**Summary of Public Comments
&
Department of Environment, Great Lakes, and Energy (EGLE) Responses
to
Wolverine World Wide's Draft Revised Tannery Interceptor System Response
Activity Plan
Public Comment Period: May 25, 2023 – June 30, 2023
Document Date: August 2, 2023**

EGLE accepted public comments regarding Wolverine World Wide's Draft Revised Tannery Interceptor System Response Activity Plan for the former Tannery Site located at 181 North Main Street NE, Rockford, Kent County, Michigan. Written comments were accepted between May 25, 2023, and June 30, 2023. The Revised Response Activity Plan outlines the design of an interceptor system to address and control per- and polyfluoroalkyl substances (PFAS) contamination in groundwater before it enters the Rogue River at the Tannery site that Wolverine World Wide (Wolverine) is required to install as outlined in the February 19, 2020, Consent Decree between the State of Michigan, Algoma and Plainfield Townships, and Wolverine. Section 7.7 (Response Activities at the Tannery) of the Consent Decree lists the objectives and requirements of the interceptor system. The Revised Response Activity Plan provides modifications to the EGLE-ap

Figure 1. The Influence of Diffusion, River Stage, and Water Elevation on Piezometer Values.

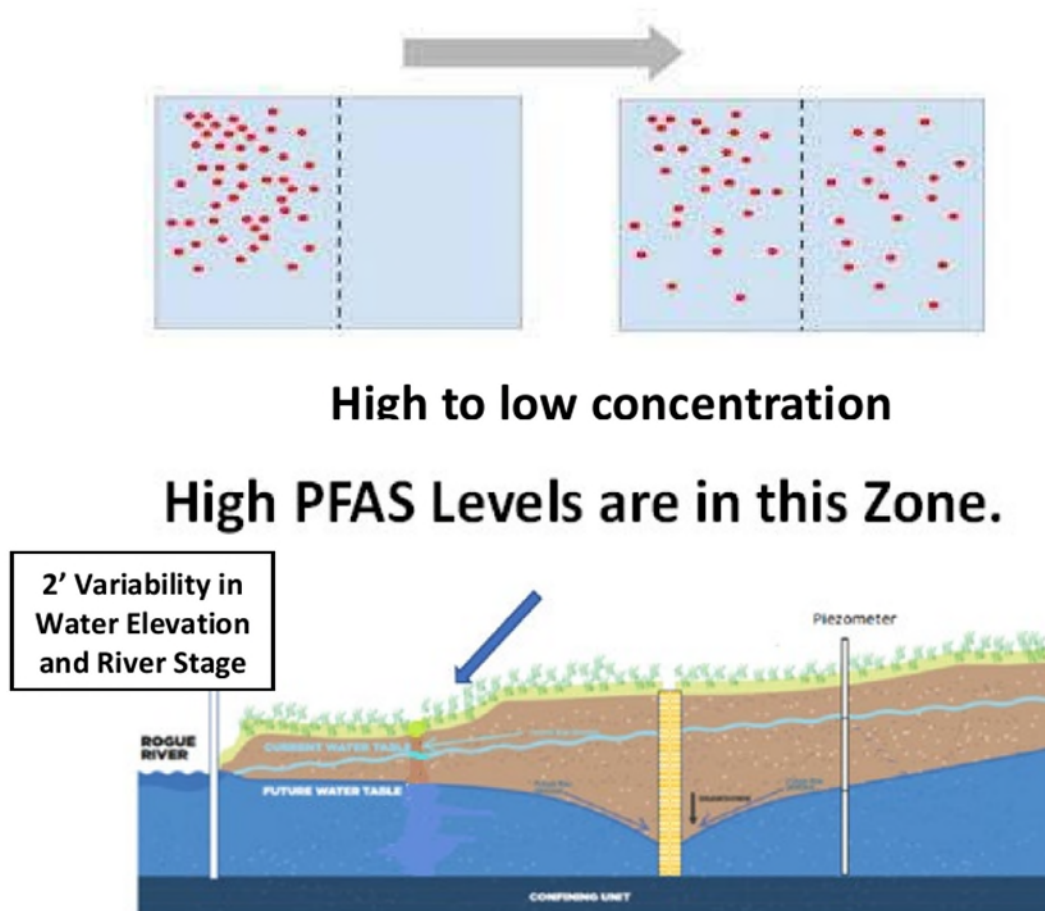
We provided a detailed description of why PFAS would migrate from the highly contaminated soils near the river to surface water by diffusion in our 1/27/23 response letter. PFAS transport will still occur by diffusion from high to low concentration gradients (site to the surface water) and from low permeability soils to the permeable gravels and sands in the stream (Fetter et al. 2017). Flowing water (especially during high flow events) and burrowing organisms will also enhance contaminant

diffusion. Due to site heterogeneity impacting the representativeness of the piezometers and issues with the conclusions about pore water and the inherent uncertainty associated with water elevation measurements (Figure 1), the only way to

reduce PFAS transport by diffusion is to maintain a negative gradient where the groundwater is not stagnant and is moving away from the river to the trench. We strongly feel that conditions where no gradient is present are unacceptable. We request that EGLE require WW to maintain a negative gradient that will prevent PFAS diffusion from high concentrations in the riverbank soils to the Rogue River and Rum Creek. We also found no reference in the revised plan to the extent of the water table drawdown that the trench system will achieve. The system should be designed to achieve a targeted drawdown level to meet the requirements of the Consent Decree.

EGLE Response: Thank you for taking the time to provide EGLE comments on this Revised Tannery Interceptor System Response Activity Plan. Wolverine is required to maintain groundwater elevation levels in the trenches that are less than or equal to the elevation of the Rogue River. The system will be designed to maintain a minimum negative gradient; however, if the elevations were ever measured to be equal to the Rogue River, Wolverine would still be considered in compliance with the requirements of the Consent Decree. EGLE is requesting that language be added to the report text to explain that a minimum gradient below the river piezometers will be maintained within the trench and deep piezometers based on the pressure transducer readings which will be collected in real time multiple times a day. If the minimum gradient is being approached or reached, then that will trigger the pumping rates to be adjusted.

The pumps in the sumps will be programmed to be activated remotely once a minimum elevation difference is detected between the transducer in the trench piezometer vs. the transducer in the river piezometer. Therefore, there will not be a week or longer response time to determine if elevations in the trenches are higher than the river.

Figure 2. Variability of Piezometer Water Elevations (GZA) and Rogue River Stage (USGS 2021 and 2022).

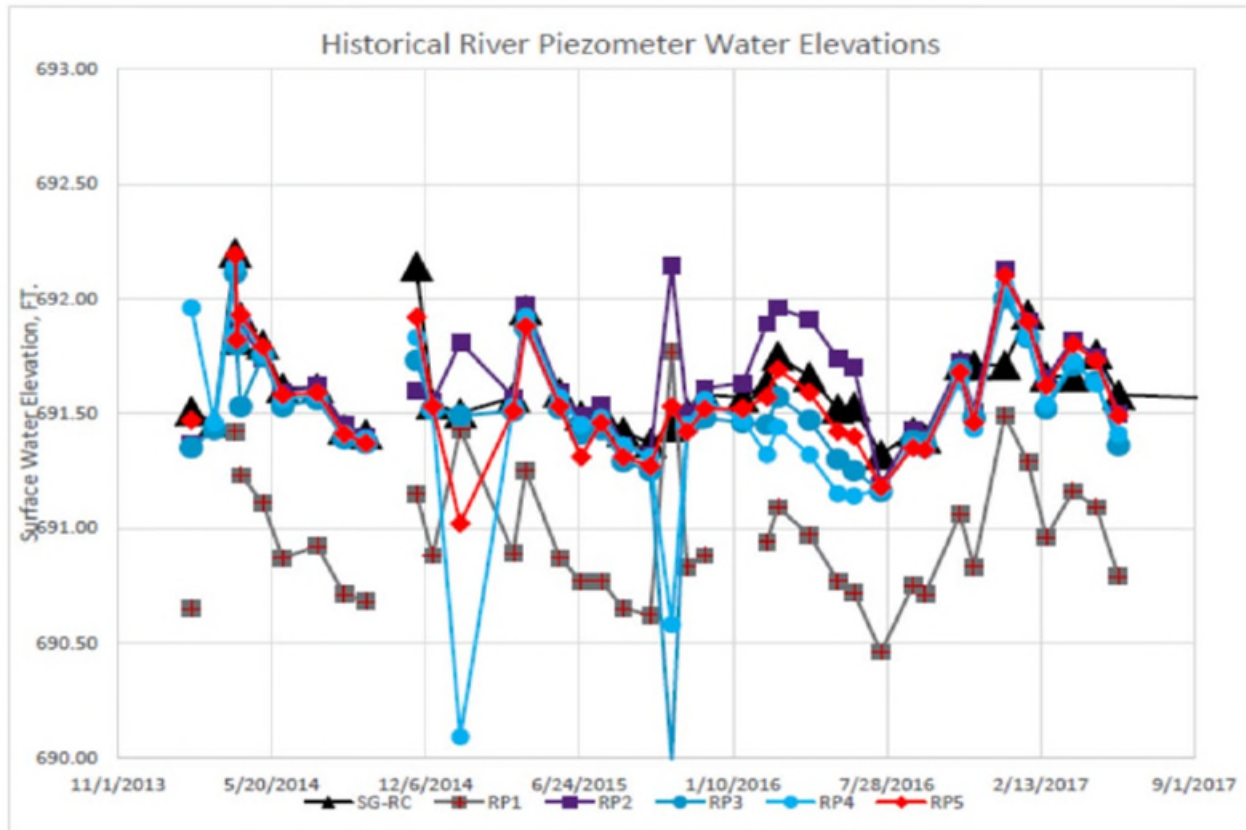
We provided information in our 1/22/23 letter that historical groundwater levels and river stages can vary over 2 ft (Figure 2). The proposed weekly monitoring schedule does not reflect the

the hydrologic complexity of the system by the time the piezometer is downloaded and processed, more than a week of noncompliance with maintaining a negative gradient may occur. Other than cost cutting, there is no reason to monitor the compliance part of the groundwater interceptor system at a lesser frequency than the levels in the sumps. We made this request in our 1/27/23 response letter, and we again are requesting that the monitoring of piezometer arrays used for water elevation measurements be automated by pressure transducers that can continuously record and transmit water level data.

Attached to this document are photos taken on from June 25, 2023—12 hours after the large rain event on June 24, 2023

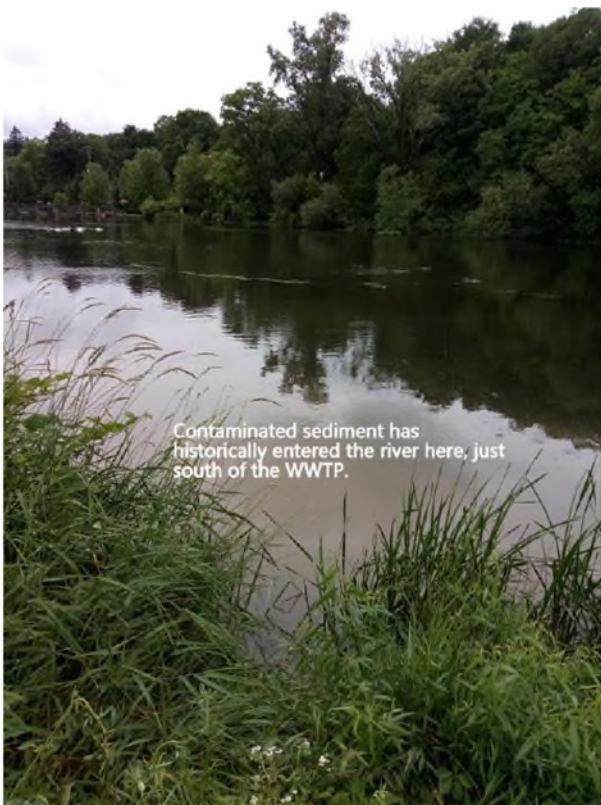
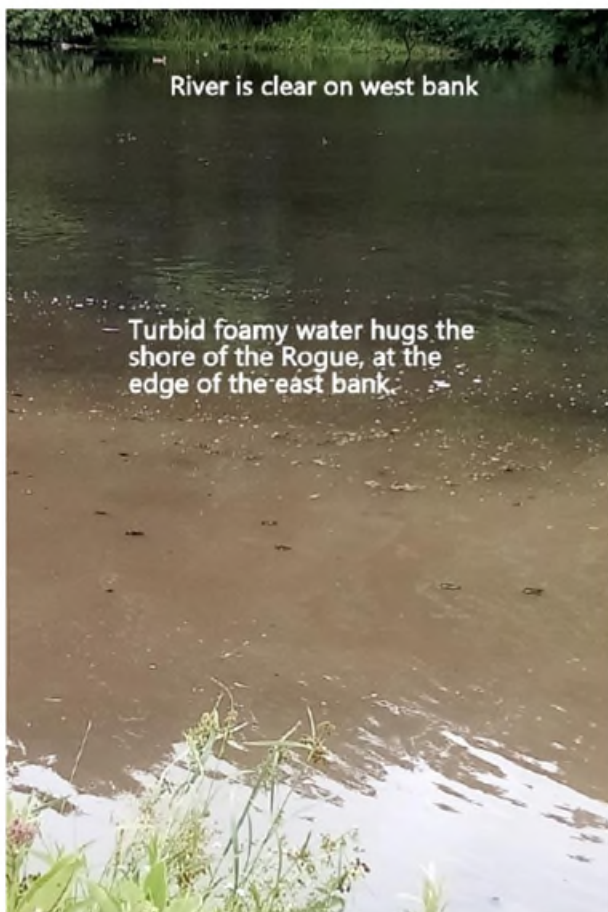
Additionally, after the large rain event on June 24, 2023, I took the following photos of the cove just south of the former WWTP area and in the area where Rum Creek flows into the Rogue River. The water was turbid, sudsy, and left a clear silt line on the river.

How much PFAS surges into the Rogue River and Rum Creek from this highly contaminated site—including storm events and spring thaws-- is not documented to a high enough degree. We need much more real time data that includes large storms, to successfully thwart the bleeding of PFAS into the Waters of the State.

EGLE Response: EGLE appreciates you taking the time to share your comments and pictures, as well as your concern for the environment. Wolverine is required to maintain groundwater elevation levels in the trenches that are less than or equal to the elevation of the Rogue River. The system will be designed to maintain a minimum negative gradient; however, if the elevations were ever measured to be equal to the Rogue River, Wolverine would still be considered in compliance with the requirements of the Consent Decree. EGLE is requesting that language be added to the report text to explain that a minimum gradient below the river piezometers will be maintained within the trench and deep piezometers based on the pressure transducer readings which will be collected in real time multiple times a day. If the minimum gradient is being approached or reached, then that will trigger the pumping rates to be adjusted.

The pumps in the sumps will be programmed to be activated remotely once a minimum elevation difference is detected between the transducer in the trench piezometer vs. the transducer in the river piezometer. Therefore, there will not be a week or longer response time to determine if elevations in the trenches are higher than the river. This remote capability to adjust pump rates will be especially important during storm events such as those you have shared.
